TOM MYERS PRESENTATION ON BEHALF OF WHITE PINE COUNTY, GREAT BASIN WATER NETWORK, ET AL.

PRESENTATION TO THE OFFICE OF THE NEVADA STATE ENGINEER

SOUTHERN NEVADA WATER AUTHORITY

REMAND HEARING

Figure 12: White River Valley portion of Plate 1, SNWA (2009a), showing springs and groundwater discharge area.

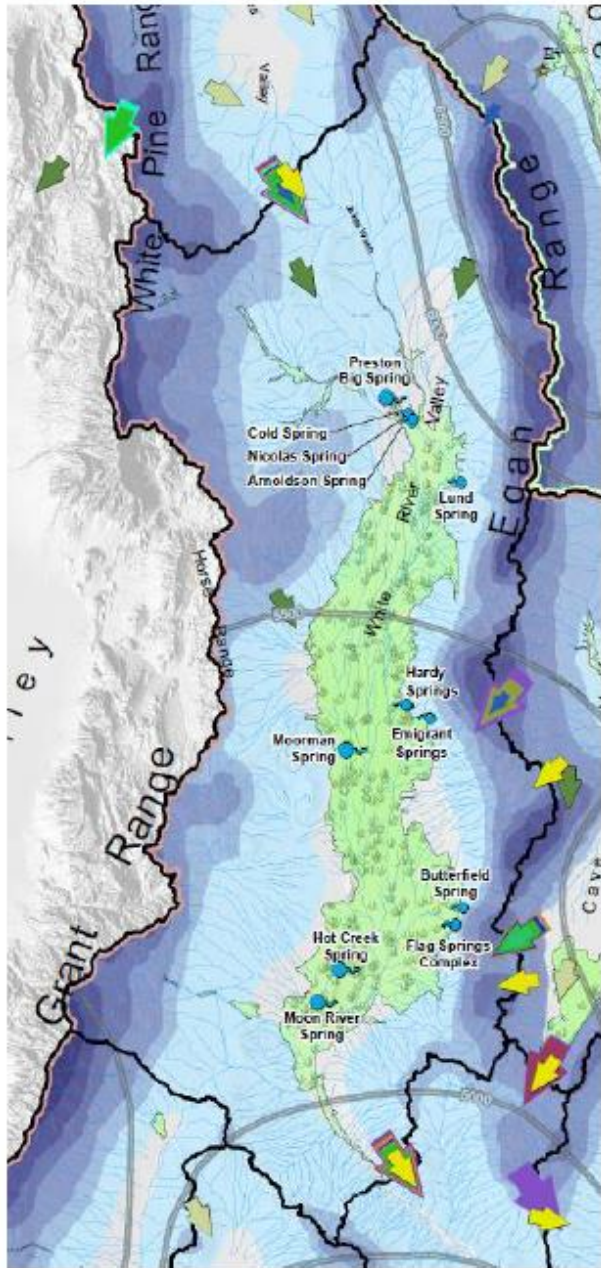
Stanka treated spring water rights as discharging from groundwater only if the springs discharged from a GWET discharge zone (Figure 12). As noted, this ignores the larger springs that discharge at the base of the mountains or on the fans. He states there are 47 irrigation rights with a spring source, and three additional White River decreed rights, presumably spring sourced, that are not in the database, and a single stream right with a POD from a spring. He then stated that 40 of these rights are within groundwater discharge areas, and “will be considered to be groundwater commitments for accounting purposes” (Stanka 2017, p 5-20). These are not listed, so it is not possible to cross-check them.² My list verifies the 47 irrigation rights, and I’ve cross-checked them with Stanka Appendix 5-32, the Place of Use of Spring Irrigation Rights (Un-sorted). Stanka lists these rights as the “40 irrigation spring rights” (Stanka 2017, p 5-21) referring to the 40 within groundwater discharge areas. Appendix 5-32 was the start of Stanka’s supplemental rights calculation. Of the 47 irrigation rights in my list, 36 were in Stanka Appendix 5-32; the appendix also lists three White River Decree rights. Stanka stated there is one stream right sourced to springs, but he does not list it in Appendix 5-32 (where the rights are all identified as having spring source). Stanka’s (2017) Table 5-10 lists 19,853 afa of water rights associated with springs and adjusted for supplemental rights. Stanka’s primary error is that he has ignored additional springs that should be considered as committed groundwater and stream rights that are also groundwater which causes an underestimate of committed groundwater rights.

Figure 4: Figure 5-11 from Stanka (2017) showing an example of supplemental pumping for Water Canyon Creek. See text for a discussion.

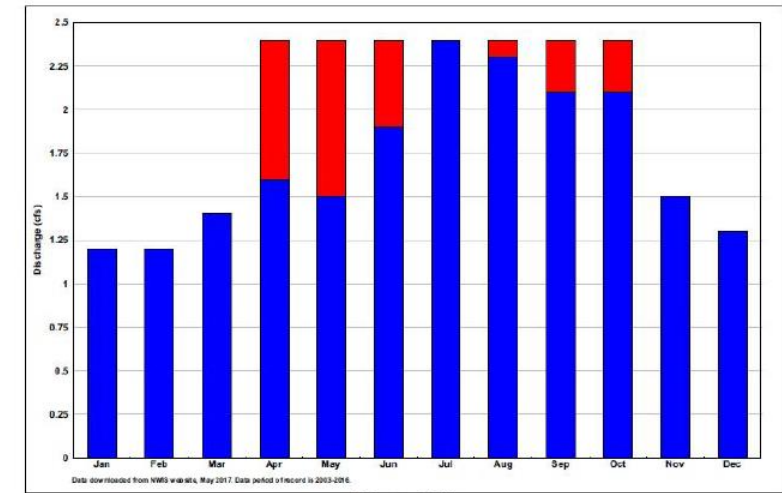
Stanka's methods would result in supplemental groundwater being 17.2 and 56.3 percent of the full appropriation for the Water Canyon and White River gages, respectively. Therefore, he used the average of 36.8 percent of supplemental UG/spring water to estimate the amount of supplemental UG/spring rights throughout WRV. Considering that the gages he used are not representative of most surface water sources in WRV (compare Figures 4 and 5 with Figure 10 in the next section), his adjustments are almost certainly inaccurate.

Figure 37: Snapshot of portion of Plate 2 (SNWA 2009a) showing surface geology and structure centered on Coyote Spring Valley with portions of surrounding valleys.

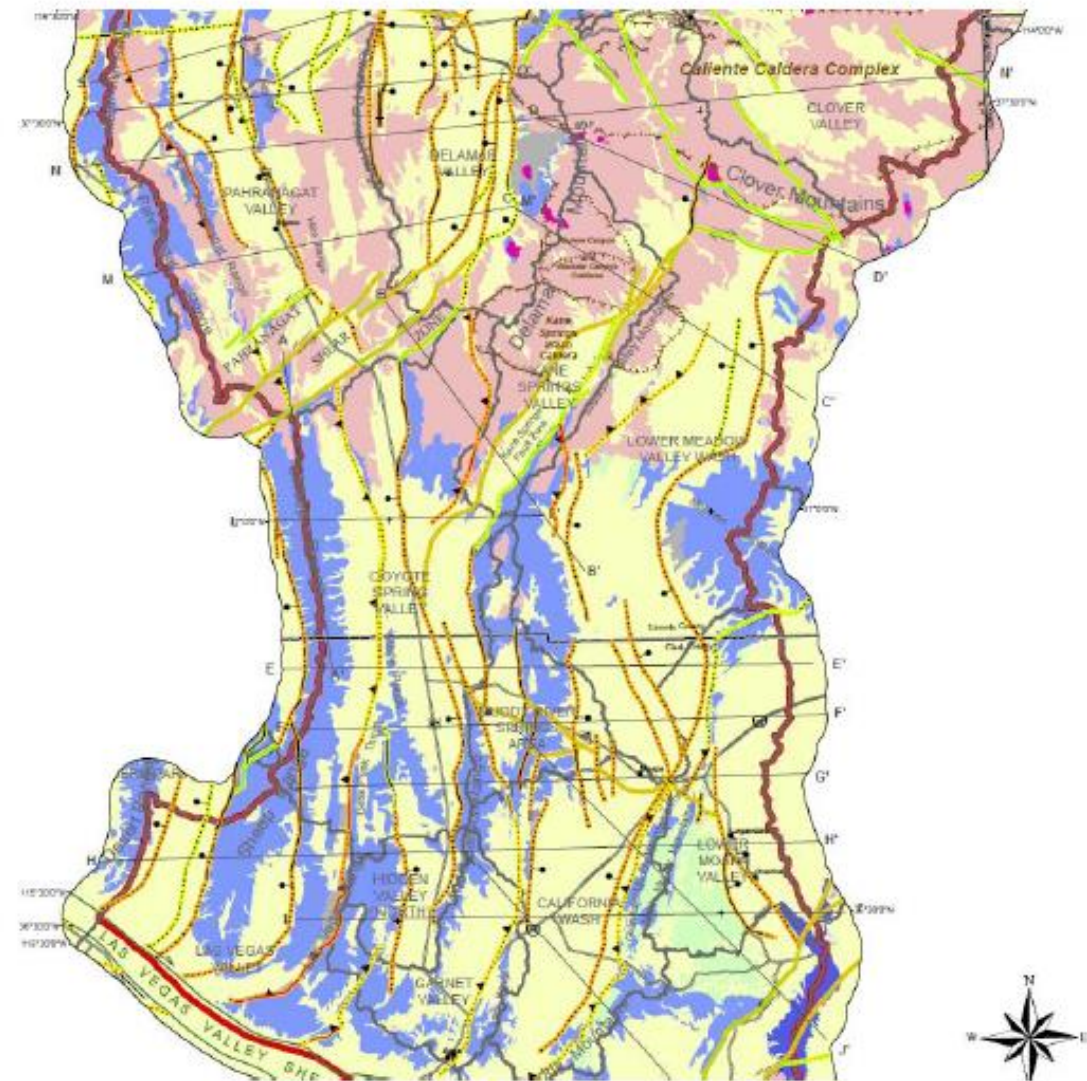
The surface formations in the southern portion of the area are generally carbonate rock with displacement faults that provide high conductivity pathways (Figure 37). The valleys are basin fill (Figure 37). North of Coyote Spring Valley there is more volcanic rock, although at depth there is some carbonate rock (Figure 37). Displacement faults provide a north-south conduit for flow, but none of the displacement faults, as simulated, connect the northern valleys such as Pahrnagat with the Muddy River Springs area (Figure 37). The Pahrnagat shear zone across the south end of that valley (Figure 37) causes the substantial drop in the water table across the shear zone (Figure 36). The model simulates the shear zone with horizontal flow barriers with relatively high conductivity carbonate rock.

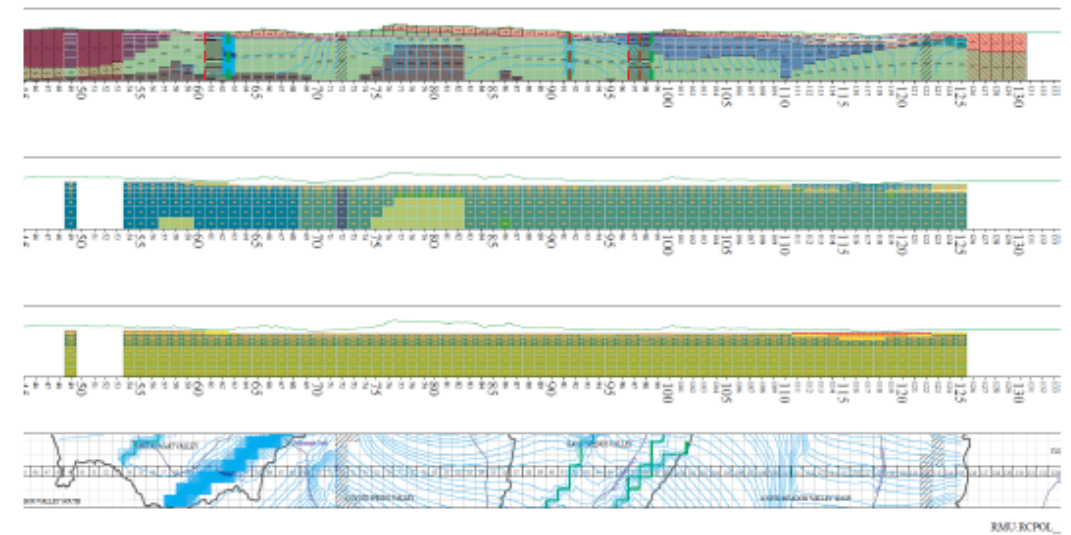
Conductivity in the seven layers in the conduit shown in Coyote Spring Valley from layers 1 through 7 is 0.0278, 22.1, 61.4, 51.8, 40.2, 27.7, and 17.7 ft/d (Figure 39). Figure 39 does not specify layer thickness but the bottom is at -10,000 feet and the upper layer is at about 2000 feet; the upper layer with low conductivity is very thin. The average conductivity of the lower six layers is 36.8 ft/d, not weighted for layer thickness because the thicknesses are not provided. Gradient across a cell is quite variable, but the contours suggest about 20 feet over 3280 feet, or about 0.0061 ft/ft. Applying Darcy’s law, the flow through just one north-south column of cells would be about 67,900 af/y. There would be flow exchange between the high K and surrounding lower K cells due to the surface not being perfectly flat. Figure 39 shows groundwater contours, in the upper cross-section showing conductivity by model cell and in the lower plan view, that converge on the high conductivity flow path that represents a fault zone.
